U. S. NUCLEAR REGULATORY COMMISSION
OFFICE OF INSPECTION AND ENFORCEMENT

Emergency Preparedness Appraisal

Report No. 50-272/81-07
50-311/81-08
Docket No. 50-272
50-311
License No. DPR-70 Priority - Category C
DPR-75 B-2
Licensee: Public Service Electric and Gas Company
80 Park Place
Newark, New Jersey 07101

Facility Name: Salem Nuclear Generating Station (SNGS), Units 1 & 2

FIG. III-1 On Site Emergency Organization

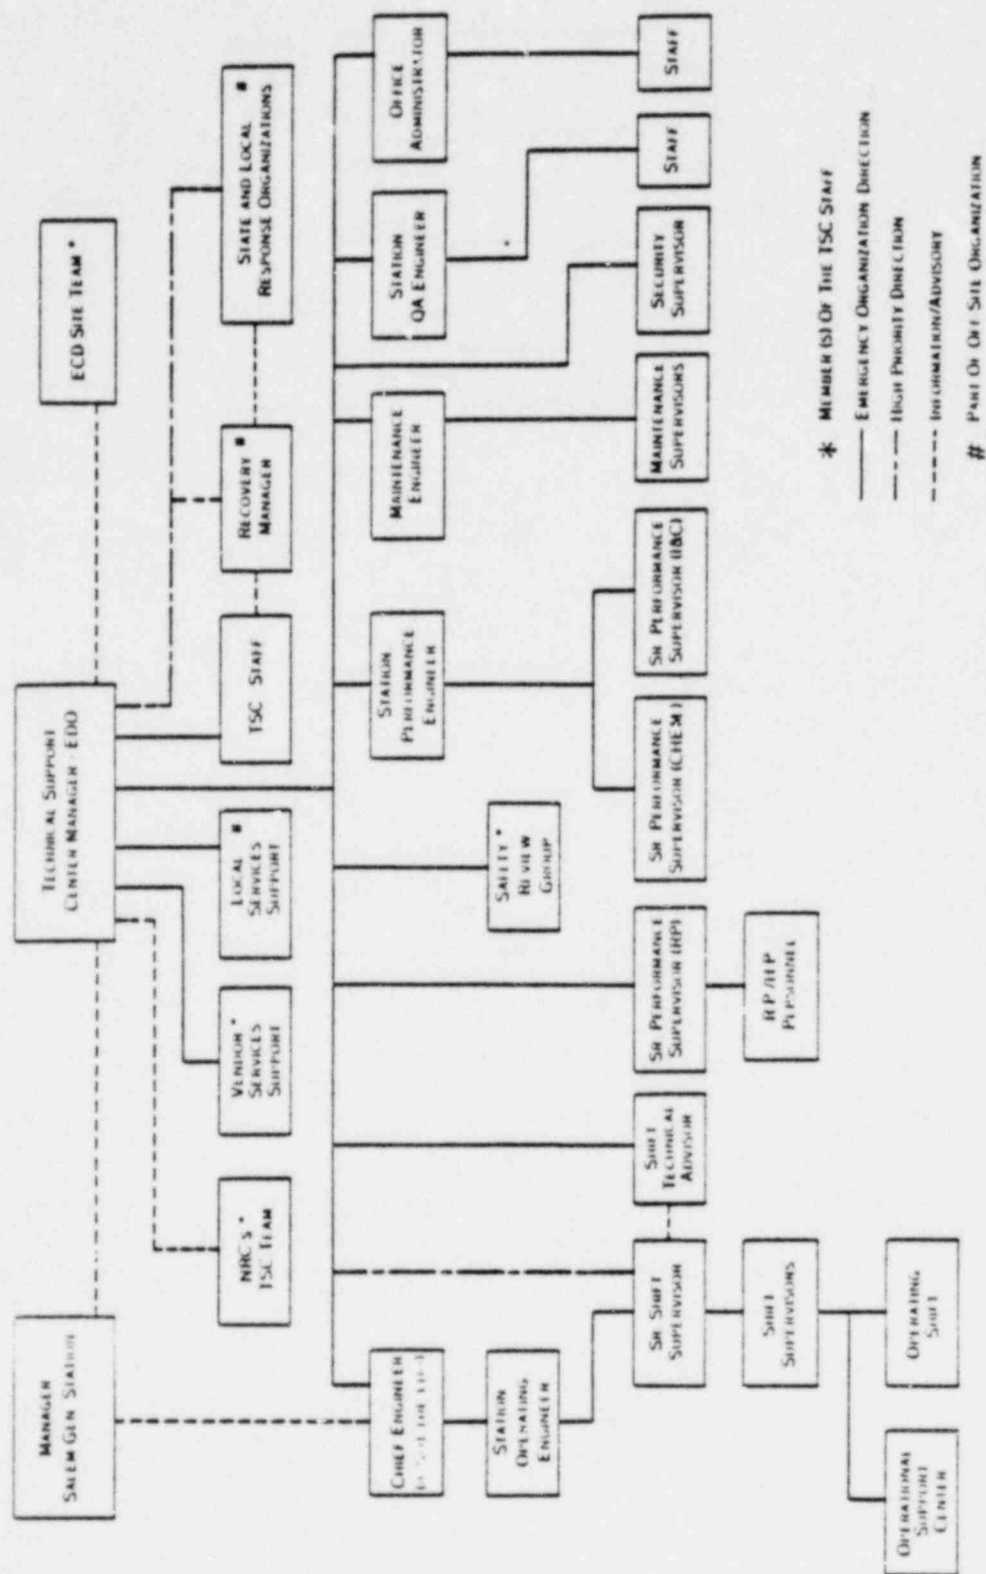
organization from Section 2.1 and 3.1 and Table III-1 of the Emergency Plan with the onsite emergency organization chart (Figure III-1 of the Emergency Plan). This organization chart is included as Figure 2 of Annex B to this report. The auditors noted that the emergency organization chart and written description of the emergency organization more closely resembled the normal organization and did not identify the relationships of the functional areas of emergency activity contained in Table III-1 of the Emergency Plan.

Within the scope of the SNGS Emergency Plan there was no clear delineation of the emergency organization in terms of the functional areas of emergency activity, assignment of responsibilities for individuals who would take charge of each functional area in an emergency, or specific interfaces among the elements of the onsite emergency organization. In many cases the Emergency Plan did not specify the individuals, by position or title, who would be selected for qualification to assume the responsibilities in each functional area of the emergency organization beyond the 90 minute minimum staffing requirements as depicted in Table III-1 of the SNGS Emergency Plan. In at least one instance the Emergency Plan referred to a position title (Performance Supervisor-RP) which was vacant within the existing station organization. In other instances the Emergency Plan indicated that certain emergency functions such as chemistry and repair/corrective actions, would be performed by teams assembled

- Revision of the description of the onsite emergency organization in Section 3.1 and Figure III-1 of the SNGS Emergency Plan to reflect functional areas of emergency activity, reporting chains (management structure) and interrelationships of the

functional areas down to the working level consistent with Table B-1 of NUREG-0654 and Table III-1 of the SNGS Emergency Plan. (272/81-07-04; 311/81-08-04)

FIGURE XIV-2 Emergency Management Plan Emergency Organization

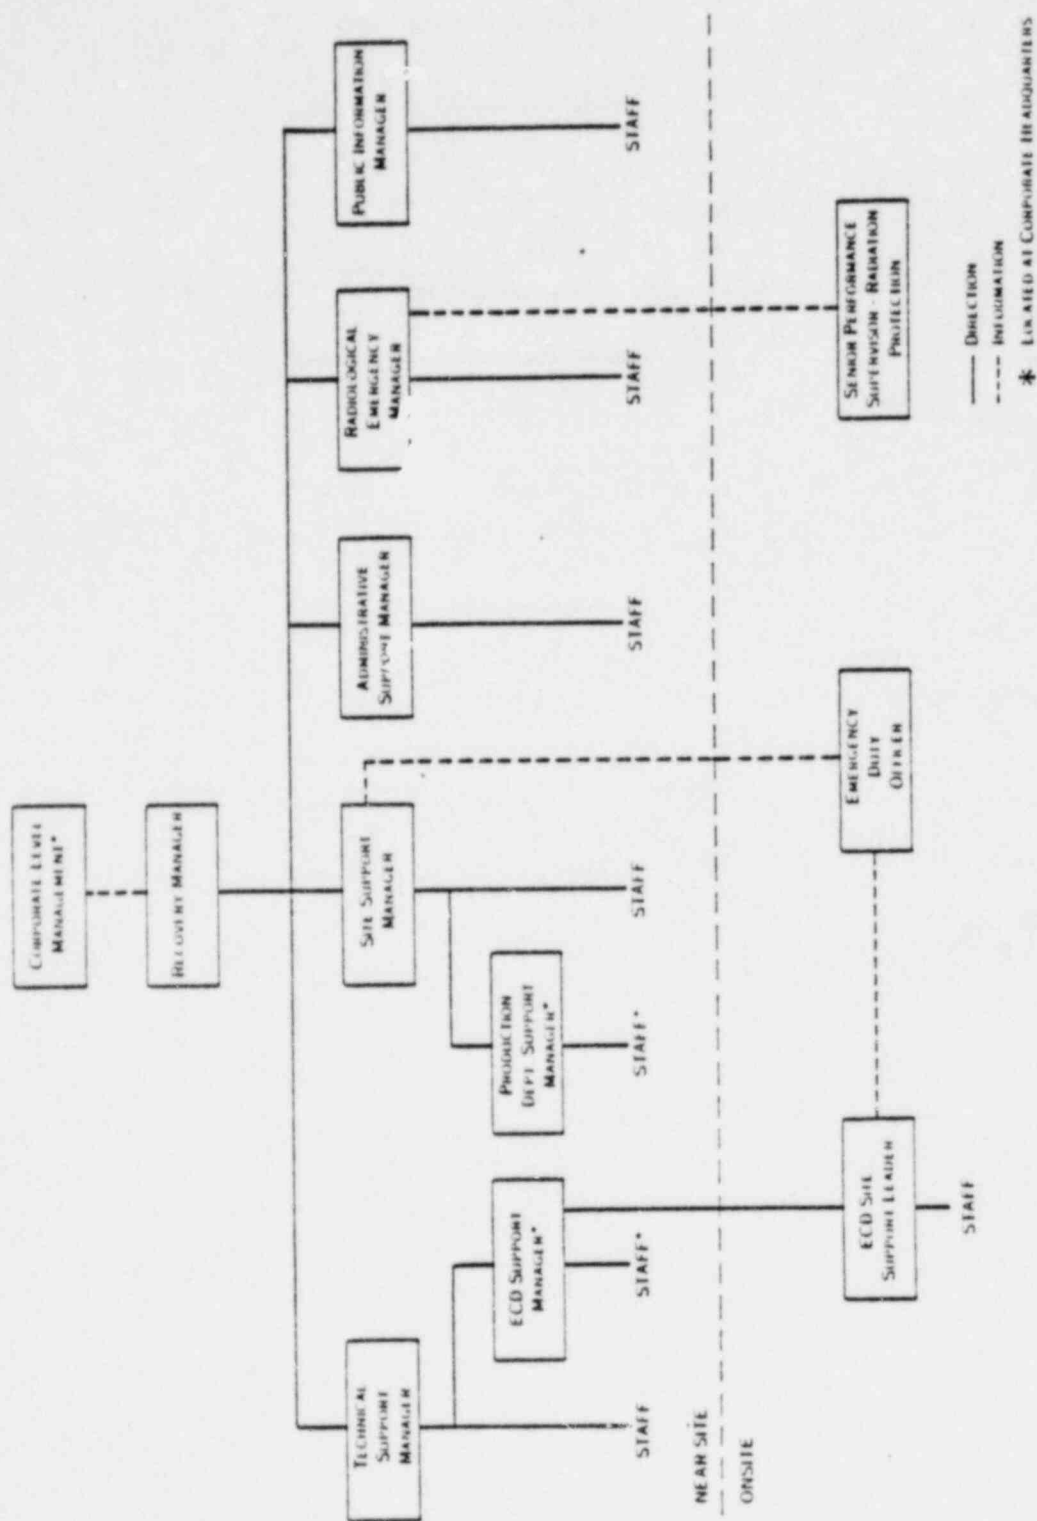
The corporate organization depicted in Figure 14-2 of the Emergency Plan and described in Section 14.0, included the positions shown in Figure 6 of Annex B to this report. The auditors noted that the description of the corporate PSE&G emergency organization in the Emergency Plan and procedures only identified the management positions that "are to act in a support and advisory capacity to the EDO."

between the RM and EDO was inconsistent with the concepts articulated in Sections 3.1 and 14.0 of the Emergency Plan and with the guidance of NUREG 0654. The Emergency Plan and NUREG 0654 set forth the concept of vesting overall coordination responsibility in a single individual and that this individual has certain non-delegatable responsibilities, among which are notifications to state and local authorities and the making of protective action recommendations to them. While Section 3.0 of the Emergency Plan stated that the "EDO shall recommend protective actions to authorities responsible for implementing offsite emergency measures," the auditors noted that Section 14.0 of the Emergency Plan and the Recovery Manual Procedures showed this function to be under the direction of the Radiological Emergency Manager (REM) who, in turn would report to the Recovery Manager. In discussing the organizational relationship of the EDO (located onsite in the TSC) to the RM and REM (offsite at the EOF) the auditors noted that there was no consistent procedural description which defined the relationship. Further review indicated that the various organizational configurations, relationships and assignment of responsibilities explained in the Emergency Plan and implementing procedures were contradictory. The resultant corporate emergency organization, therefore, did not properly interface with the station organization, since the functional areas identified did not correspond to the functional areas of the station emergency organization. There was no clear reporting chain to provide information to the single individual having the authority for overall responsibility

- Revision of the Emergency Plan and implementing procedures to clearly identify the functional areas of emergency activity support to be provided to the station organization, reporting chains, and the interfaces between the corporate and non-licensee augmentation organizations and the station emergency organization down to the working level (272/81-07-06; 311/81-08-06).
- Inclusion of an approved list of licensee personnel (by name) and non-licensee organizations in the Emergency Plan implementing procedures who have been selected and are qualified to perform activities within the functional areas of the corporate emergency organization to which they are assigned (272/81-07-07; 311/81-08-07).
